Amendments to the Drawings

Annotated Sheet Showing Changes

FIG. 23

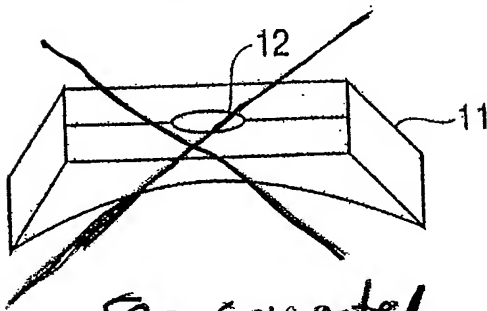
The attached sheet of drawings includes changes to Fig. 23. This sheet, which includes Figs. 21-24, replaces the original sheet including Figs. 21-24. In Fig. 23 the upper surface of the coupling element has been corrected to be concave, as originally shown in Fig. 3, for example, rather than flat as originally, mistakenly drawn.

*See corrected
Fig. 23 with
concave upper and
lower surfaces*
